AV Lite Proposal

To: T13 Technical committee
From: Jim Hatfield
 Seagate Technology
 389 Disc Drive
 Longmont, CO 80503
 Phone: 720-684-2120
 Fax: 720-684-2711
 Email: James.C.Hatfield@seagate.com
Date: January 14, 2003

- Dec. 18, 2002 - Approved by T13
- Jan. 13, 2003
 - TBD values assigned by T13
 - Minor clarifications added
 - Set DWE if Stream Error occurs during a write or flush command
- Jan 15, 2003
 - correct typos, misspellings

Figure 1

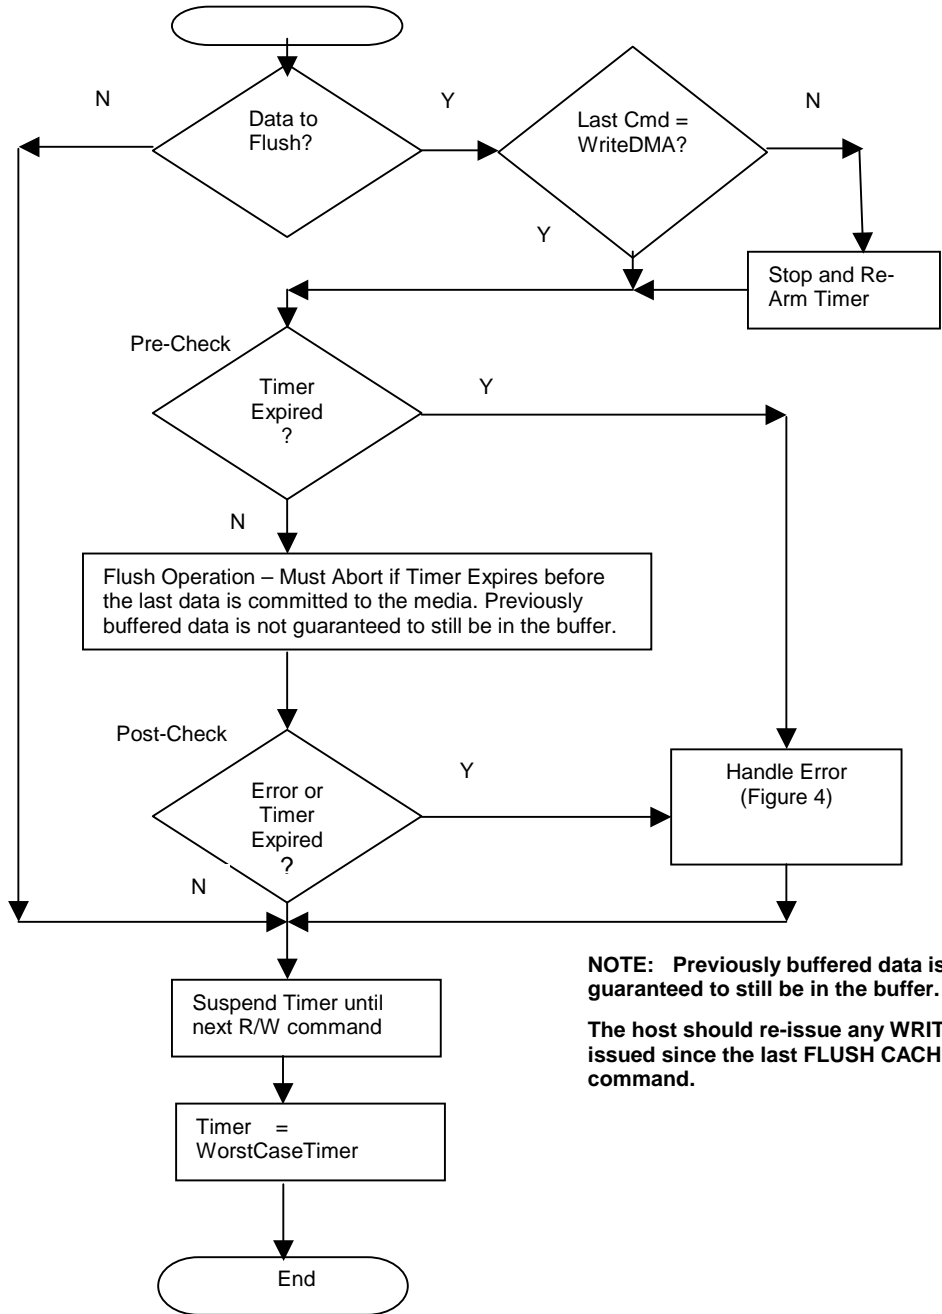
2.4 FLUSH CACHE Changes

If A/V Lite is supported and enabled, the following algorithm shall be used:

NOTE: Previously buffered data is not guaranteed to still be in the buffer.

The host should re-issue any WRITES issued since the last FLUSH CACHE command.

Figure 2

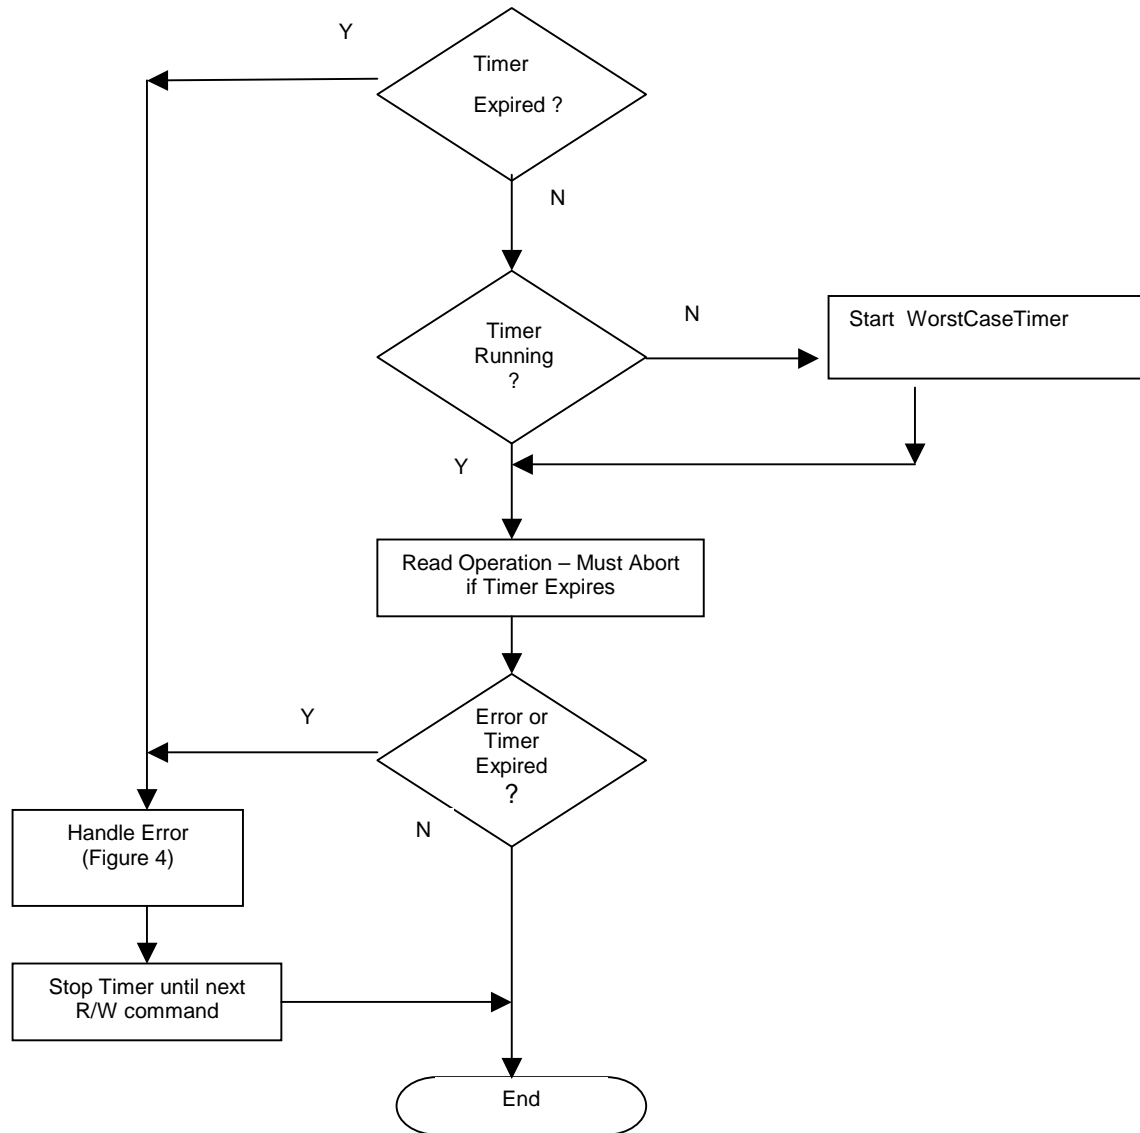
2.5 READ DMA and READ DMA EXT command changes

If A/V Lite is supported and enabled, the following algorithm shall be used:

Figure 3

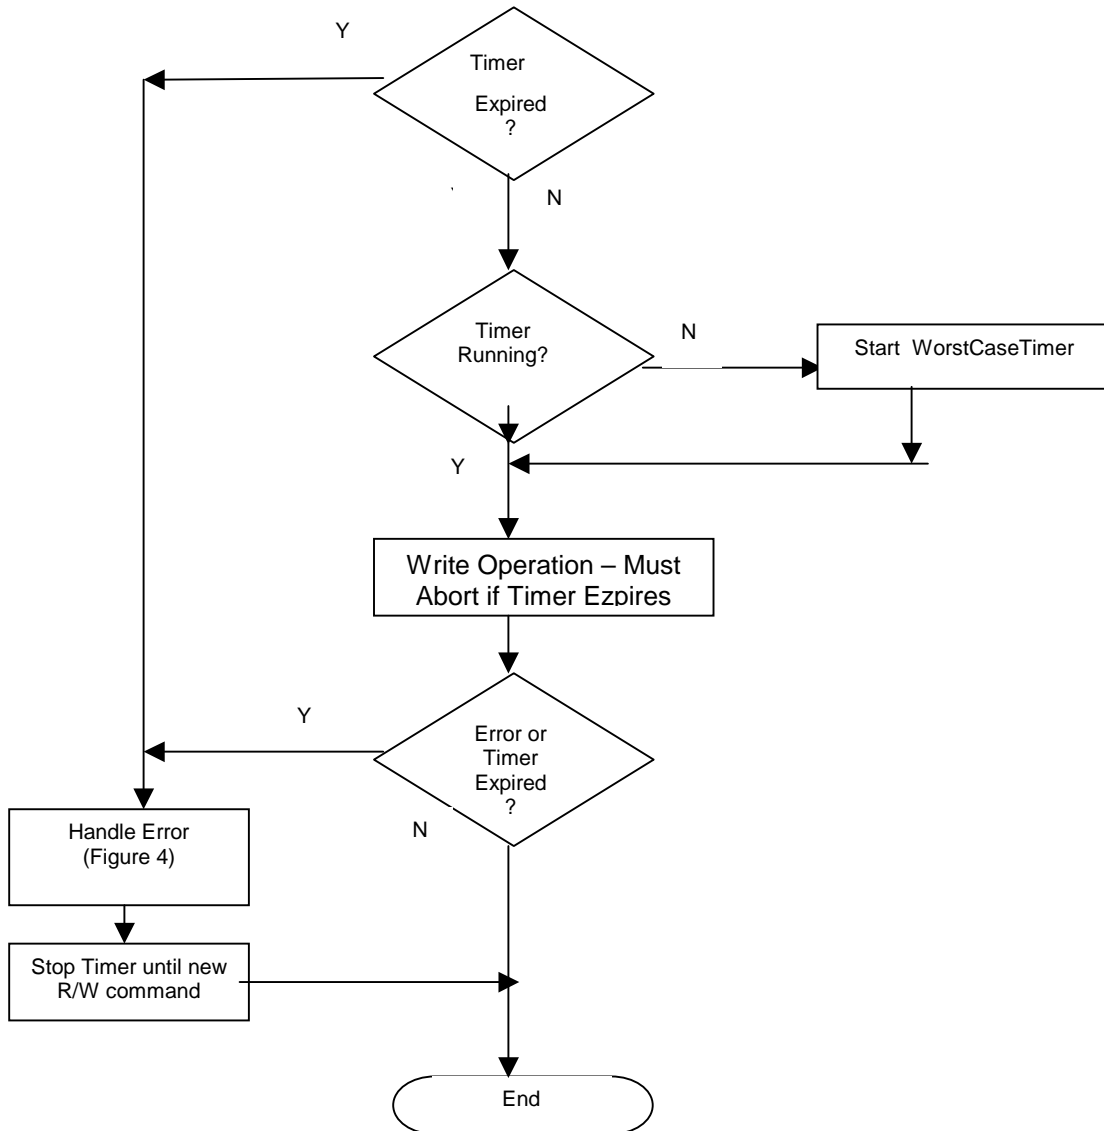
2.6 WRITE DMA and WRITE DMA EXT command changes

If A/V Lite is supported and enabled, the following algorithm shall be used:

Figure 4

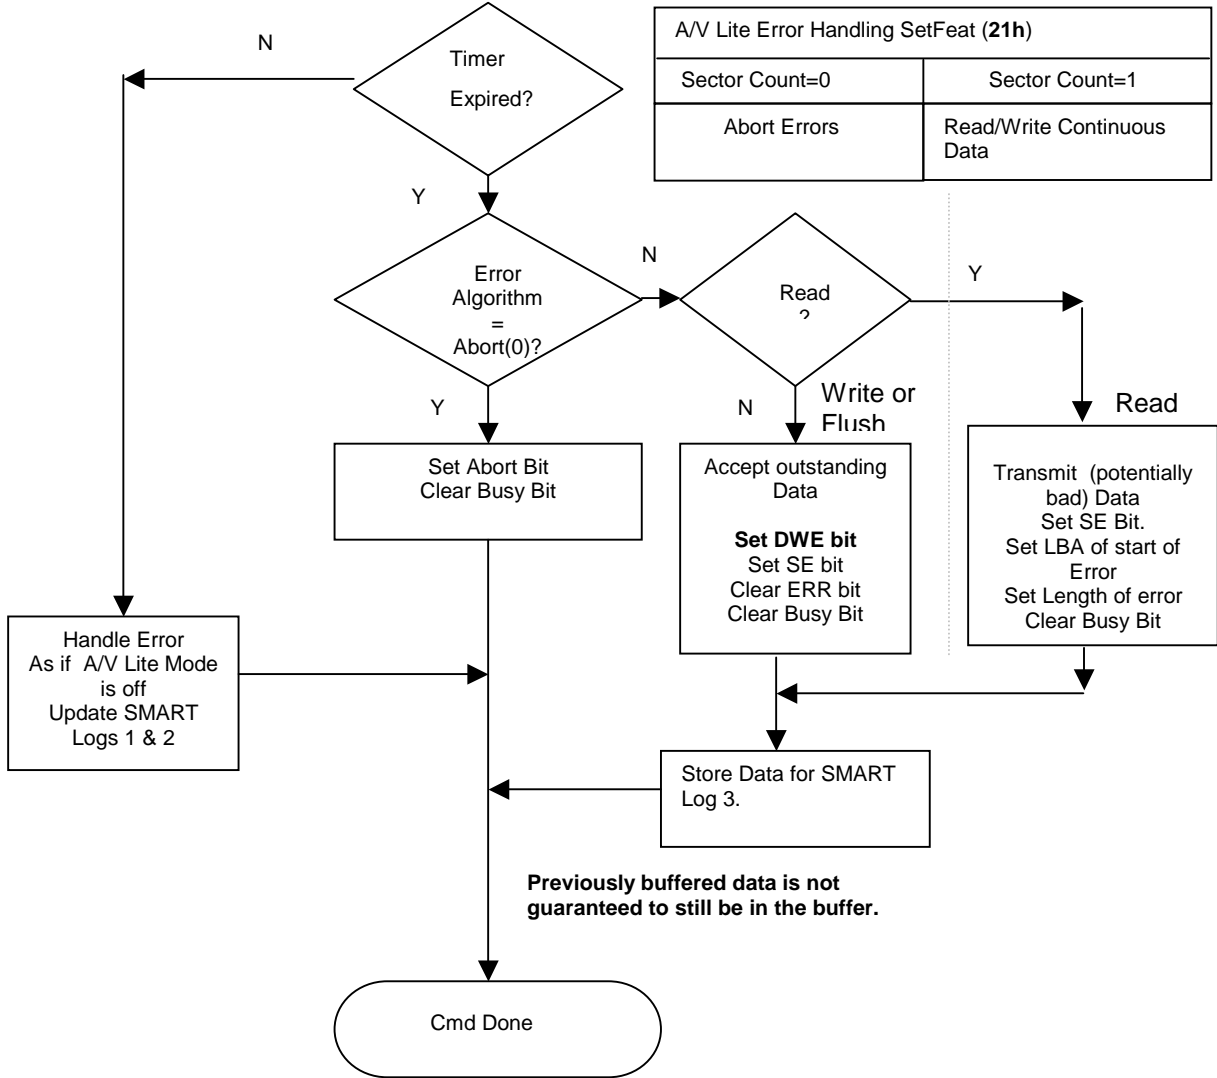
2.7 ERROR HANDLING

Two error handling algorithms are supported:
 Abort the Command and report the LBA of the Aborted Command; or
 Transfer “garbage” data if data is not currently available.

The algorithms are selected via the Set Features Command –
 Features Register = **20h** and **21h**
